MIDWAY MFG. CO.

TABLE OF CONTENTS

S E R V I C E B U L L E T I N

ANTI-PENNY DEVICE INSTALLATION

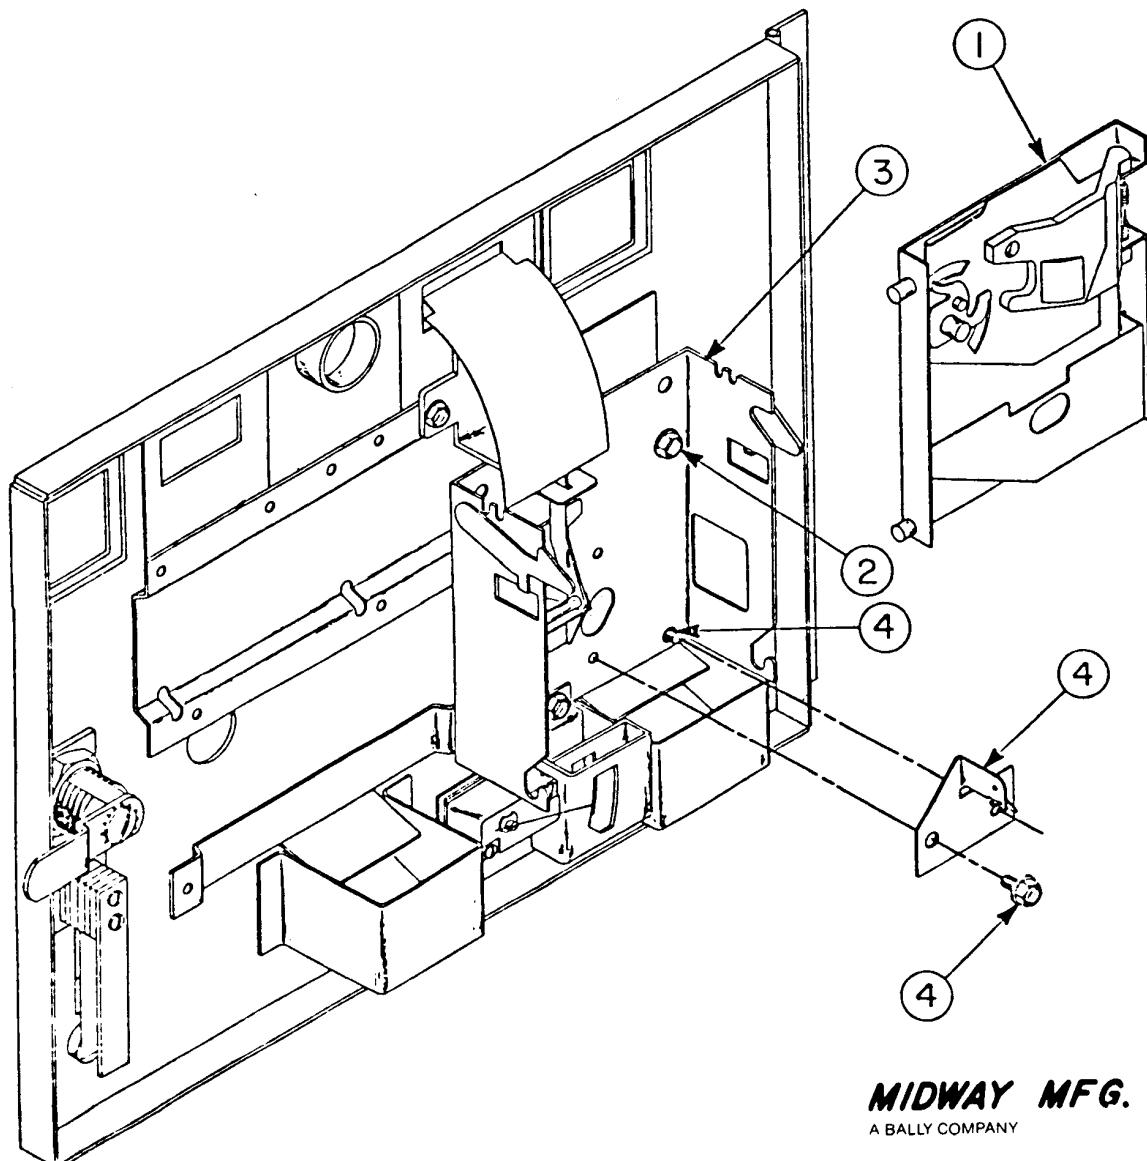
CONDITION: Flipping pennies into return cup for free games.

Order from the Midway Parts Department an Anti-Penny Device Field Kit.
Part number A090-00064-0000.

1. REMOVE COIN ACCEPTOR FROM BRACKET.
2. REMOVE (3) HEX HEAD SCREWS THAT HOLD BRACKET TO DOOR.
3. REMOVE BRACKET FROM DOOR.
4. INSTALL ANTI-PENNY DEVICE MIDWAY PART NO. A090-00064-0000 USING (2) 6-32 x 5/16 SLOT HEX HEAD SCREWS MIDWAY PART NO. 0017-00101-0555. MOUNT DEVICE WITH 1 SCREW FROM THE FRONT AND 1 SCREW FROM THE BACK OF BRACKET AS SHOWN.
5. SCREW BRACKET BACK TO DOOR AND SNAP COIN ACCEPTOR BACK IN PLACE.

ANTI-STRING DEVICE INSTALLATION

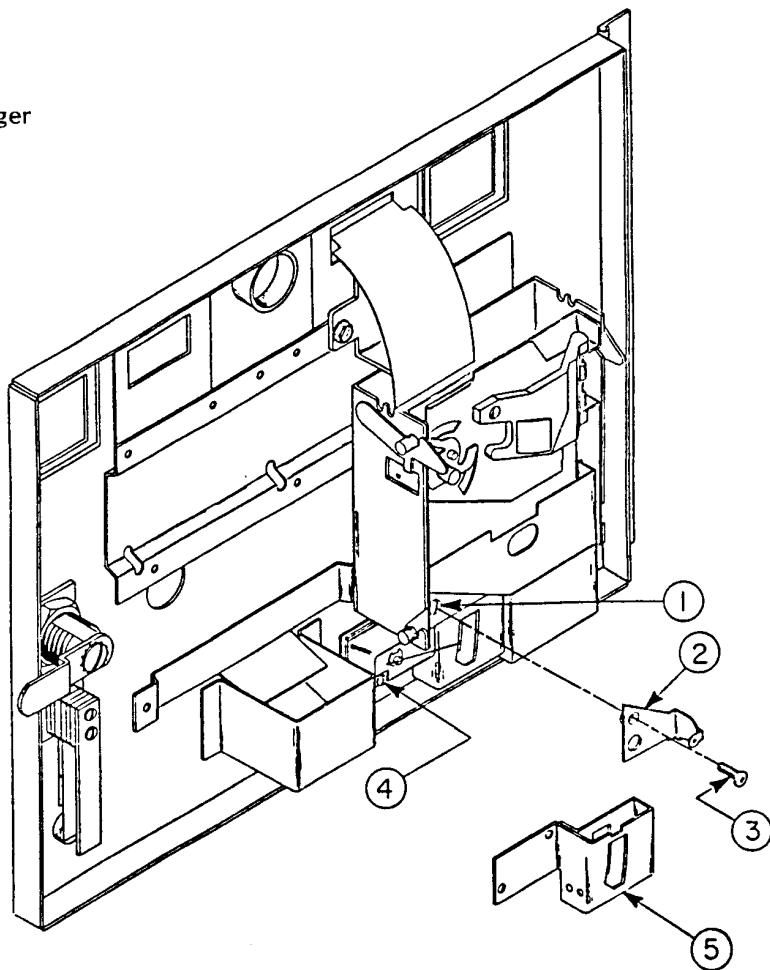
1. REMOVE 1/8 LONG SLOT HEAD MACHINE SCREW.
2. INSTALL ANTI-STRINGING DEVICE MIDWAY PART NO. 0090-00907-0000.
3. REPLACE 1/8 LONG SLOT HEAD MACHINE SCREW (STEP 1) WITH 3/8 LONG SEMS PHILLIPS HEAD MACHINE SCREW. MIDWAY PART NO. 0017-00101-0339.
4. REMOVE (2) #4 SLOT HEAD MACHINE SCREWS WHICH MOUNT MICRO SWITCH AND SWITCH COIN GUIDE ASSEMBLY.
5. REPLACE SWITCH COIN GUIDE ASSEMBLY WITH NEW SWITCH COIN GUIDE ASSEMBLY MIDWAY PART NO. A090-00060-0000. MOUNT MICRO SWITCH USING (2) #4 MACHINE SCREWS REMOVED IN STEP 4.

FIGURE 1

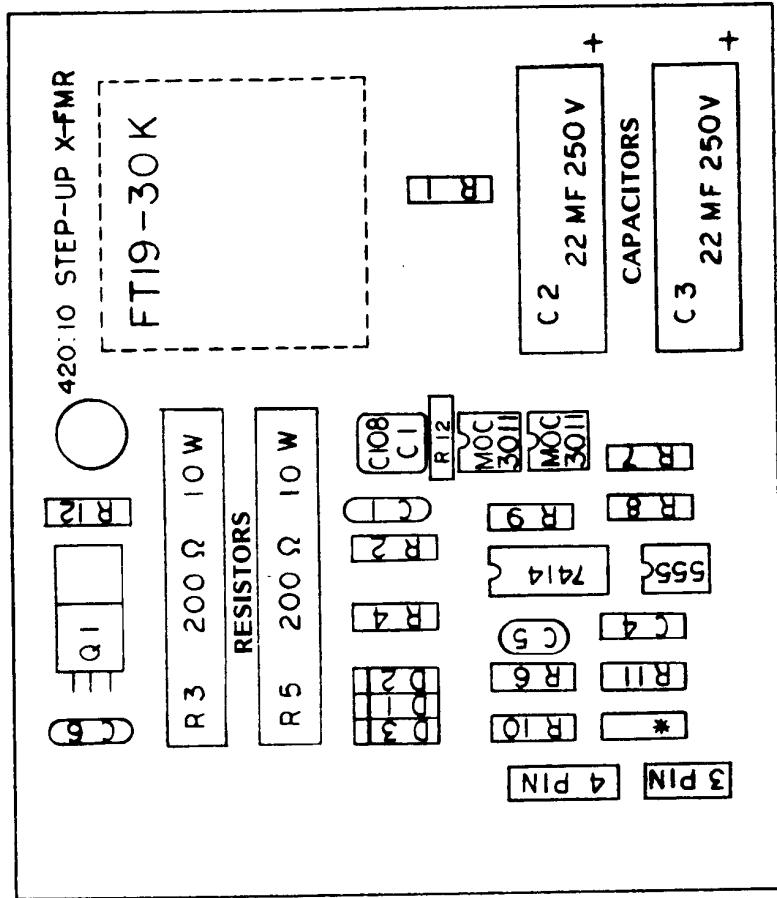
SUBJECT: Strobe unit PC A084-91359-B645
Serial No. 101 to 3700

MODIFICATION: (see figure #1)

1. Change resistor R3 and R5 to one of the following values.
 1. 300 ohms, 20 watts. 10%.
 2. 310 ohms, 20 watts. 10%.
2. Capacitor C-2 and C-3 should be 22MF., 250 V.
3. Check electrically.

**NO. 645-SPACE ENCOUNTERS-UPRIGHT
SWITCH AND HAND GRIP ASSEMBLY INSTRUCTIONS**
(KIT ASSY. NO. A645-00042-0000)

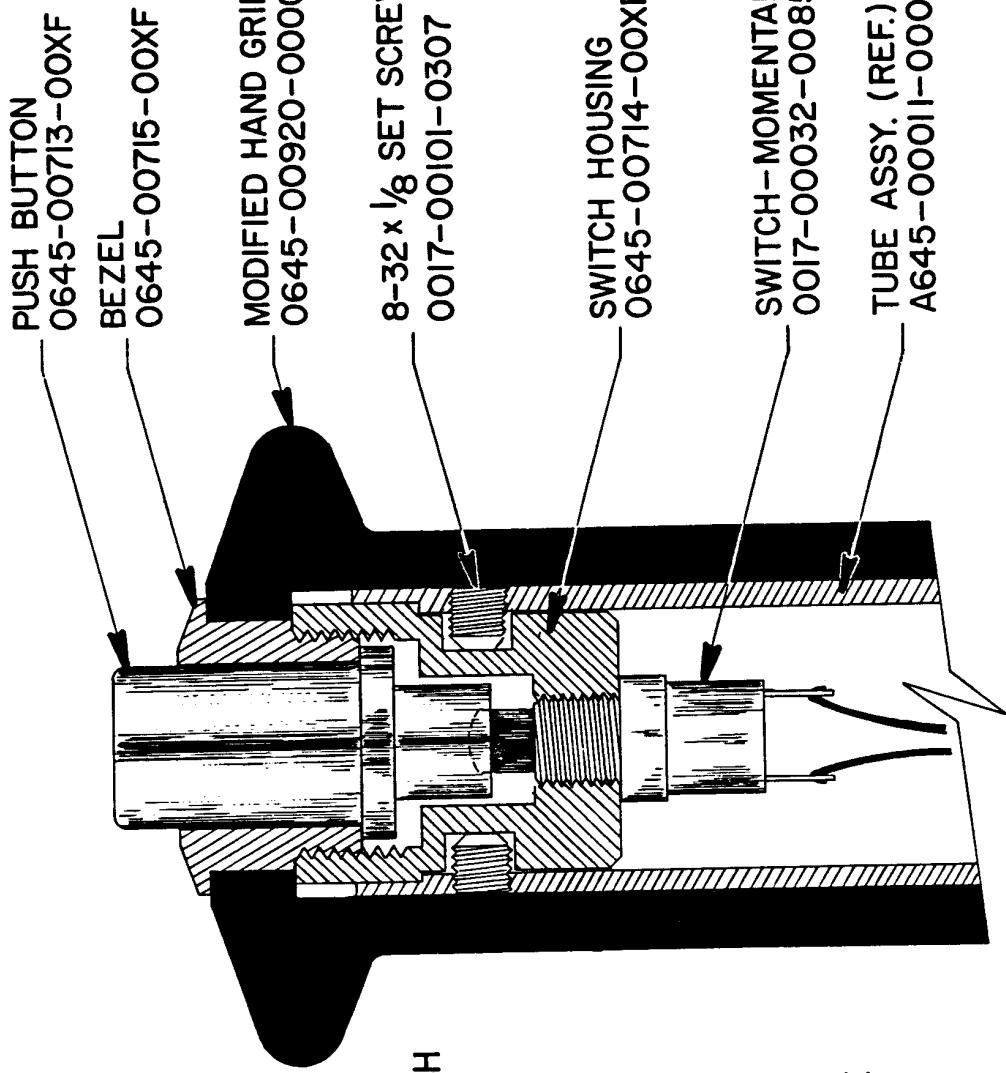
1. Due to field failures a new trigger switch is now available.
2. The switch and hand grip assembly kit may be ordered from the parts department. (A645-00042-0000).

- APPLY LOCTITE NO. 242 (P/N 0017-00009-0238) TO ALL THREADS BEFORE ASSY.
- SWITCH TO BE WIRED PRIOR TO ASSEMBLY.
- SCREW SWITCH INTO BOTTOM OF SWITCH HOUSING UNTIL SHOULDER BOTTOMS ON SWITCH HOUSING AS SHOWN.
- SLIDE SWITCH AND HOUSING ASSY. INTO TUBE. TIGHTEN SET SCREWS(2) TO RETAIN.
- SLIDE PUSH BUTTON INTO SWITCH HOUSING.
- PUSH RUBBER GRIP ONTO TUBE UNTIL FULLY SEATED.
- PUSH BEZEL ON PAST LIP OF RUBBER GRIP AND ENGAGE THREADS. TIGHTEN UNTIL FULLY SEATED.

INSTRUCTIONS TO ADJUST CONTROL PANEL: "B" VERSION

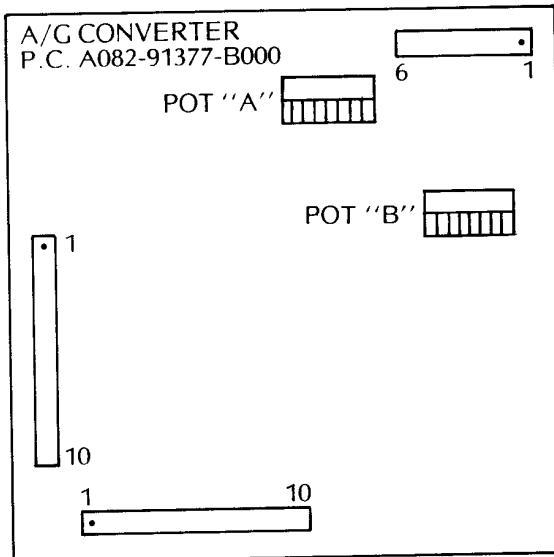
1. Due to a shortage of Encoders some games will have 25K pots. (two)
2. For proper operation of pots a A/G converter. PC A082-91377-B000 has been added.
3. The A/G Converter PC is mounted under the control panel.
4. Refer to instruction adjustment for proper pot alignment.

1. Place adjustment switch (5) "OFF" and (6) "ON".
2. Press trigger button, located on steering control to set test mode.
3. On P.C. board A082-91377-B000, rotate Pot A clockwise and Pot B counter-clockwise.
4. Push steering control forward, rotate vertical pot until defense ship is in its' furthest position. Back off pot until ship starts to come back down. Tighten set screw.
5. Put steering control in its' furthest out position. Rotate Pot A until defense ship stops in lower part of viewing area.
6. Put steering control all the way to the left.
7. Turn horizontal pot until defense ship is to the left side of the tunnel.
8. Tighten set screw.
9. Turn control to the right and adjust Pot B until the defense ship reaches the right side of the tunnel.

Figure #1

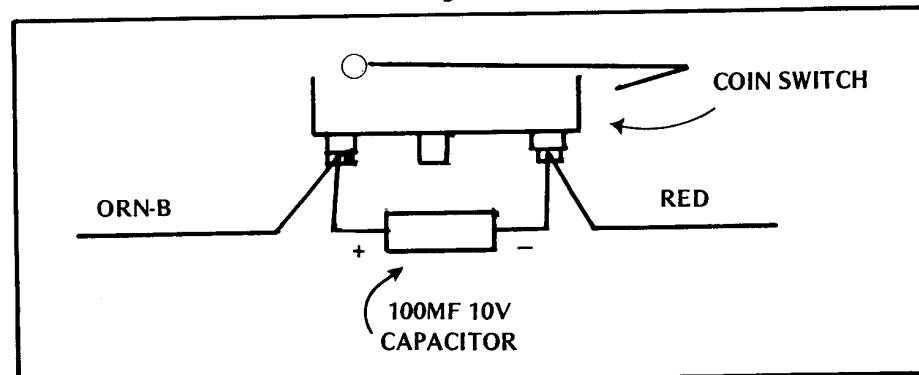
SUBJECT: Loss of Credit

1. Install 100MF 10V capacitor to coin switch terminals as shown in Figure #1.
2. Capacitor is only needed at one coin switch.
3. Check game electrically.

FIGURE 1

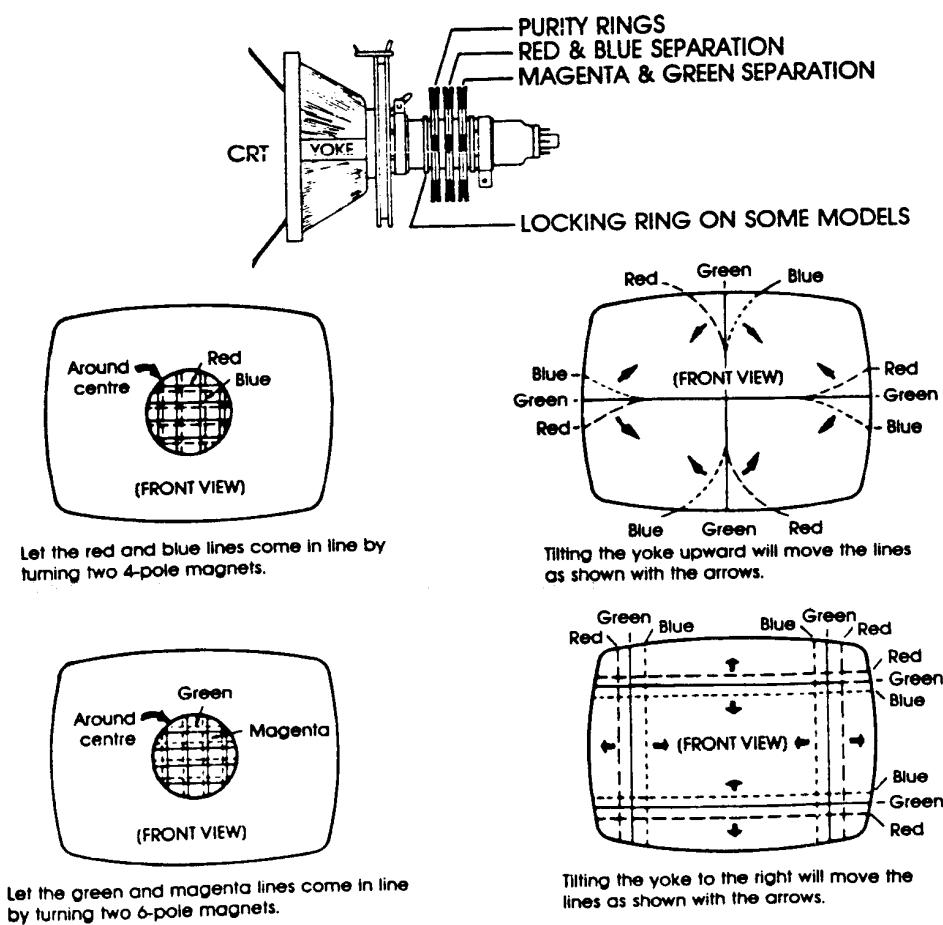
Static convergence (in the center of the monitor) is achieved by manipulating four magnets located on the neck of the CRT nearest the base of the tube. The middle pair of rings adjust the red and blue crosshatch. The rear pair of rings adjusts the blue/red to the green crosshatch lines. Dynamic Convergence is handled by tilting the yoke up, down, left and right, then securing it with wedges. Refer to the game schematic for Diagnostic Tests that generate crosshatch and background colors.

- A. Tilt the yoke up, down, left and right to achieve convergence around the edges. Secure with one temporary wedge.
- B. Rotate the center rings to adjust the red and blue separation.
- C. Rotate the rear rings to adjust the magenta (red-blue) and green separation; when best results are obtained, seal the rings with nail polish.
- D. Remove the temporary wedge from the yoke. Tilt the yoke again to adjust the edges of the screen for minimum separation and insert three new wedges. These should have adhesive added to hold them permanently.

Figure #1

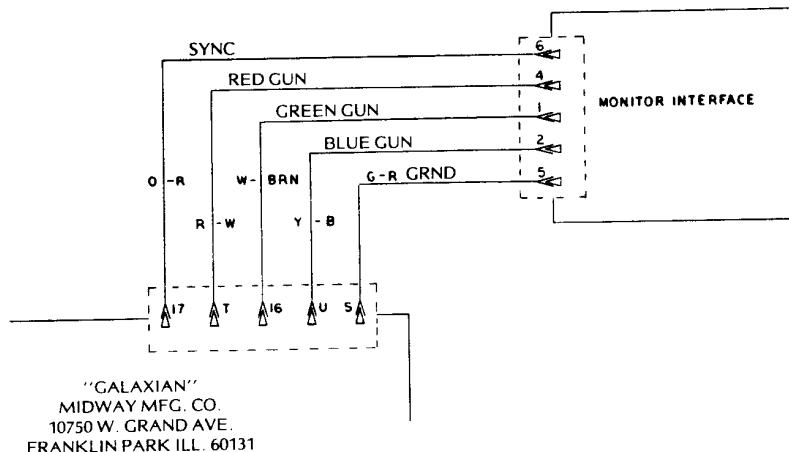
1. Proper video cable wire sequence for interface PC, Wells Gardner color monitor 19K4500. (See Figure #1)

Figure #2

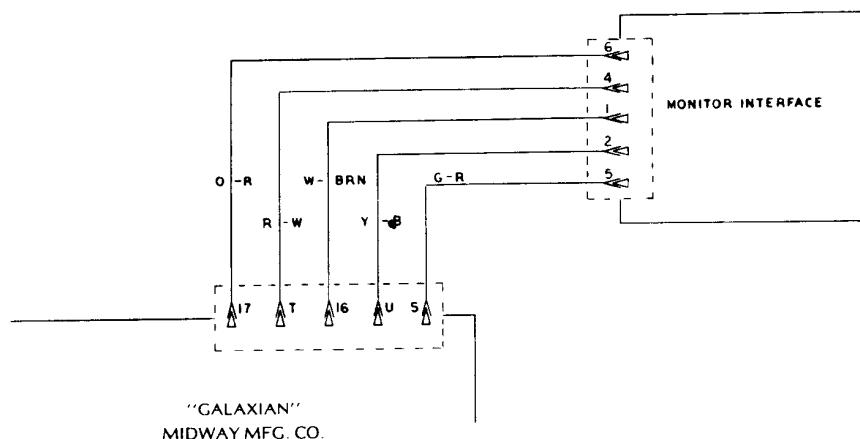
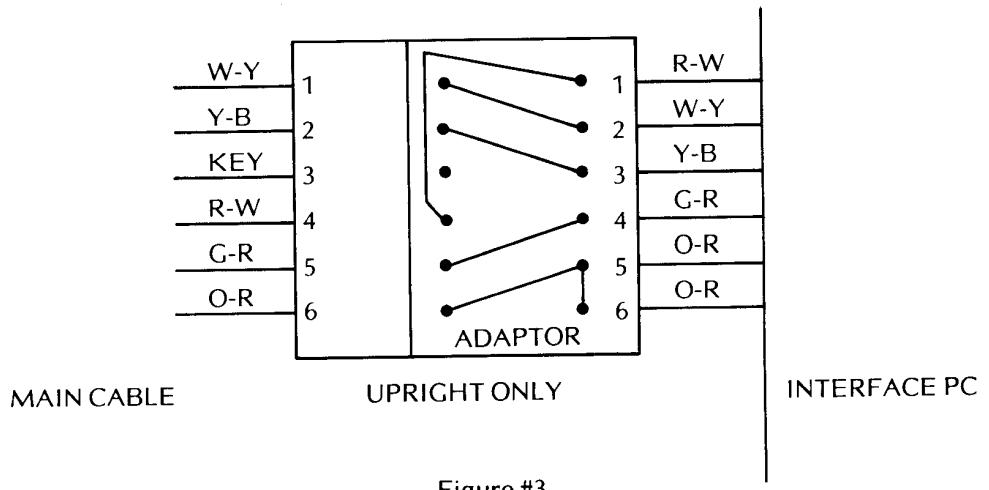
2. Proper video cable wire sequence for interface PC, Wells Gardner color monitor 19K4601. (upright) (See Figure #2)

NOTE: The cocktail table main cable is wired for the Electrohome monitor and must be altered when installing a Wells Gardner monitor. (Same wire sequence as above)

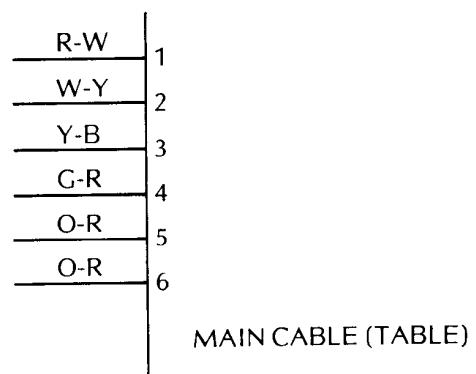
3. Proper video cable wire sequence for interface PC, Electrohome 19" color monitor G07 - 901 & 905 (upright & cocktail table). (See Figure #3)

- NOTE:
1. The adaptor Jack PC A080 - 91106 is used in upright games for proper wire sequence.
 2. The cocktail table wire sequence if for the Electrohome Monitor.

Figure #4

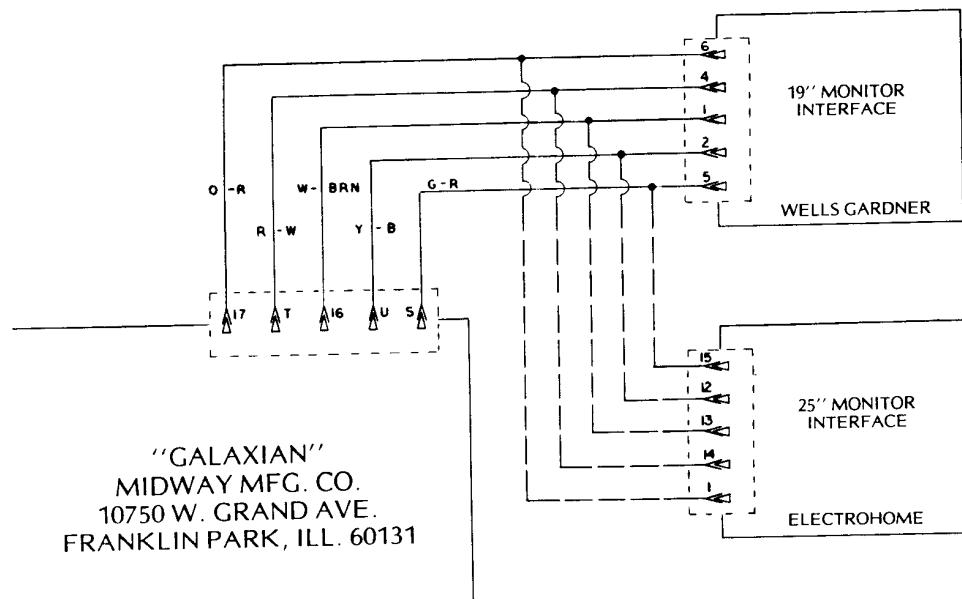
4. Proper video cable wire sequence for interface PC, Electrohome color monitor, G02 - 25 inch (upright). (See Figure #4)

NOTE: Due to cable changes and other modifications the 25 inch color monitor must be used.

Figure #5

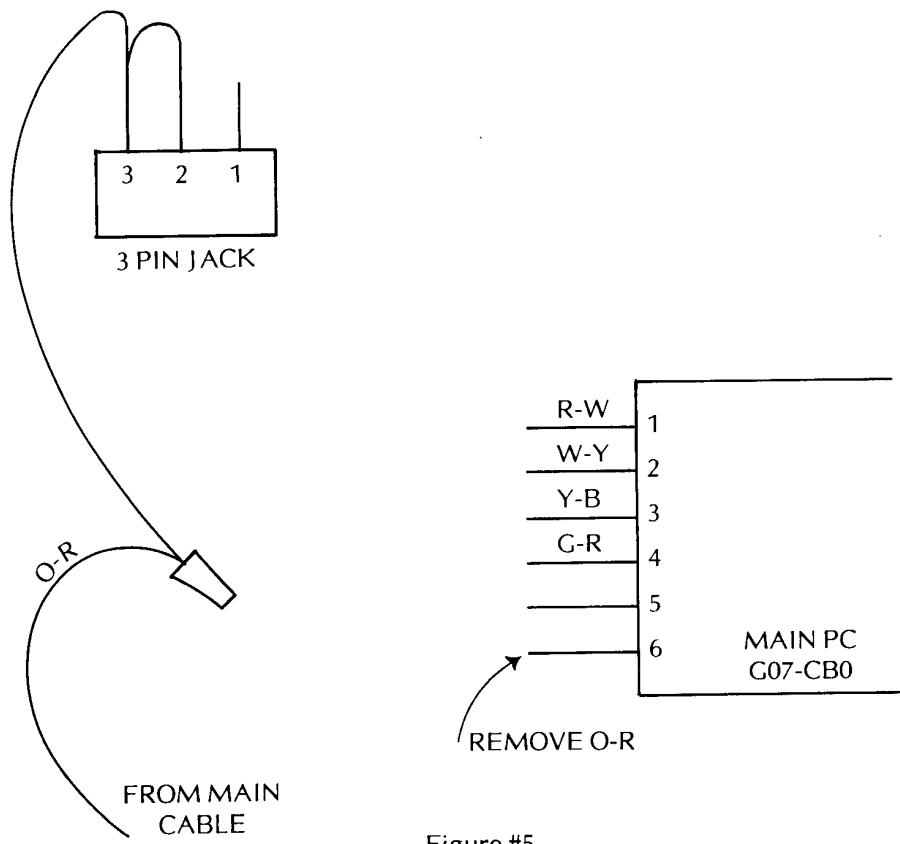
5. Proper video cable wire sequence for interface PC, Electrohome color monitor G07 CB0 - 904. (upright & cocktail table). (See Figure #5)

- NOTE:
1. The adaptor jack PCA080 - 91106 is used to eliminate wire changes in upright games.
 2. Not used in cocktail table games. (PCA080 - 91106).
 3. The orange - red must go to 3 pin jack as shown.

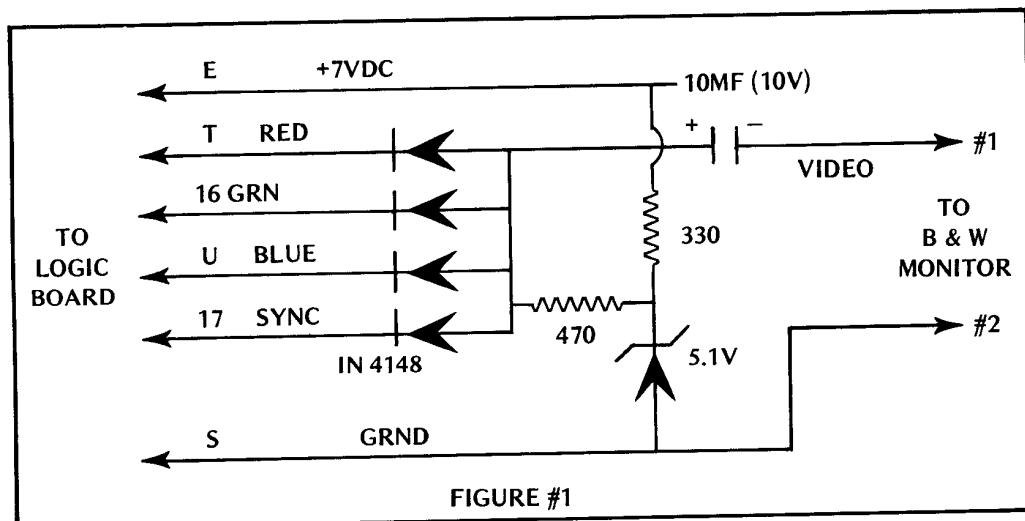
To bench test a Galaxian logic board with a black and white monitor, the following change must be made (see Figure #1):
